To: Alex Nemeth

From: Stephen DiCicco

Date: 7/22/2011

Subject: RAMPP West Virginia LiDAR QA/QC: Coal River Delivery

Figure 19 – A flight line ridge in tile C21975.

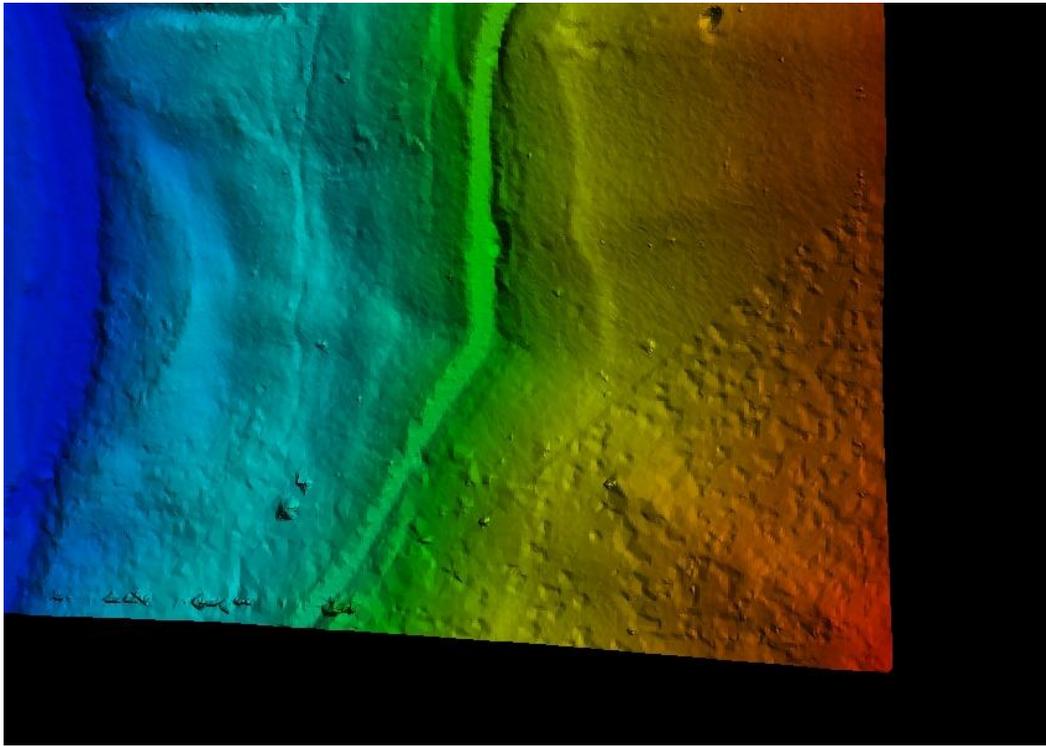
As previously mentioned, a limited number of flight line ridges were detected in the QA sample. These occurred in areas previously determined to contain flight line offsets. Figure 19 shows a flight line ridge present in tile C21975. While ridges are generally linear like that in Figure 19, other flight line ridges in the data were affected by inconsistent classification and have varying patterns.

Figure 20 – Noise is present on the left side of both hills. Tile C22432.

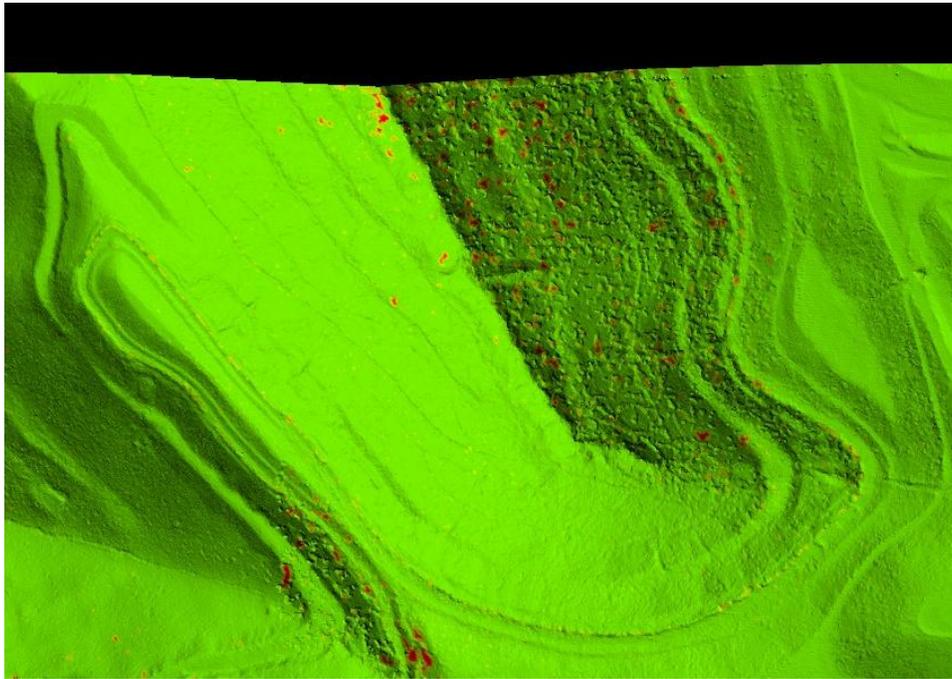
Several tiles contained noise over 20 cm. Often one side of a slope appears noisy while the other side does not. Figure 20 shows an example of this. Some noise corresponds with flight line ridges and is a result of classifying points to ground from flight lines that are offset.

Figure 21 – Negligible corn rows in tile C25077 averaging 10 cm. Correcting these corn rows is recommended but not required.

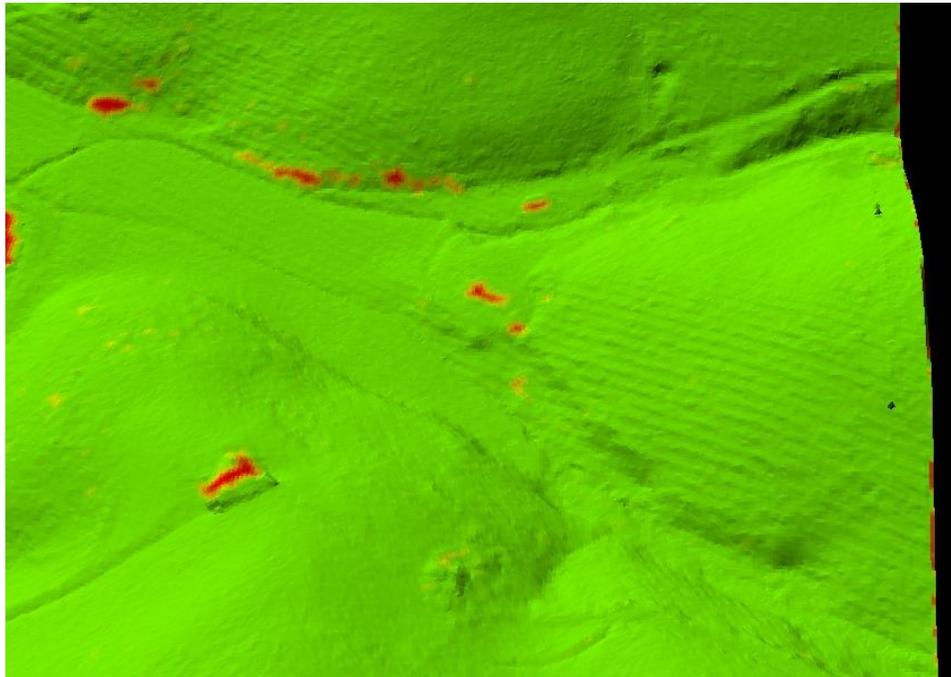
Corn rows are present in the LiDAR data. These occur when overlapping scan lines are slightly offset from each other. For portions of a scan line, typically the outer edges, point returns take on an alternating pattern as they become less frequent. Typically, LiDAR points from an overlapping flight line are added, and the pattern is undetectable. If the two flight lines do not match vertically, however, the points will not mesh and a false pattern of alternating higher and lower relief will appear in the ground model. This affect is known as corn rows.

The West Virginia project specifications require a vertical error of 30 cm or less at the 95% confidence level. Based on this specification, corn rows exceeding 15 cm are considered errors which require reprocessing. No cornrows which could be reliably measured as exceeding the 15 cm tolerance were found in the data. Some instances of cornrows which average between 10 and 14 cm were observed. These were noted in LiDAR QA assessment and, while they do not strictly require adjustments, it is recommended that these corn rows be corrected both to improve the quality of the ground model and to identify possible flight line offsets. Figure 18 shows corn rows averaging 10 cm.

Figure 19 – Points are sparse enough that the scanner pattern becomes visible. This is noted for QA assessment, but is not expected to be resolved.

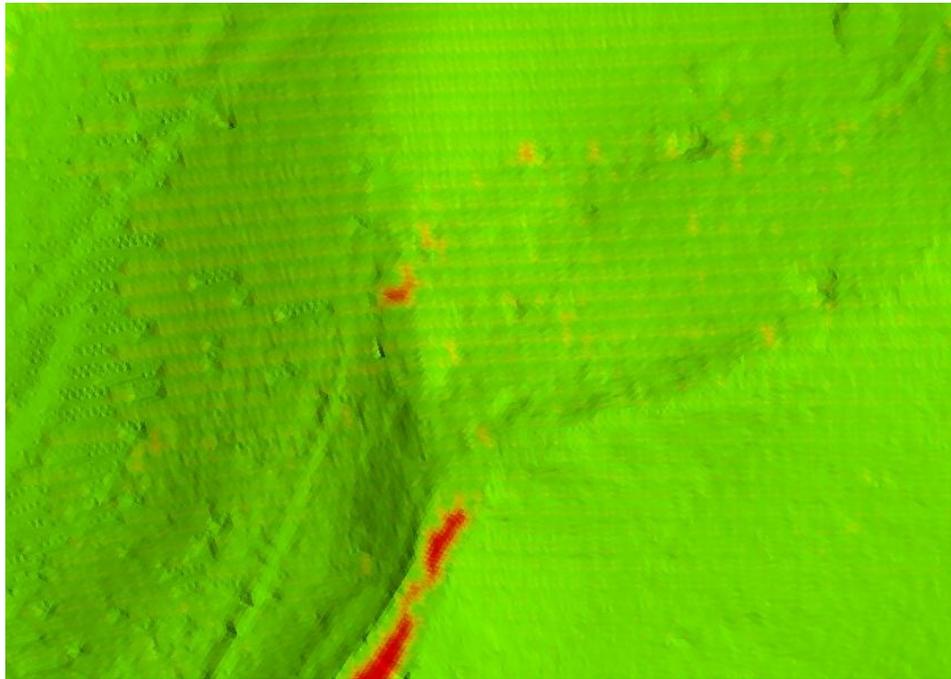
One additional inconsistency was noted. For a small number of cases, often bordering an area of cornrows, point density was low enough that the scanner pattern was clear in the ground density model. This cannot be easily fixed, however it does not greatly impact the ground model. Figure shows the linear pattern present in the ground density model for tile C27958. The yellow lines represent a scarcity of LiDAR points.
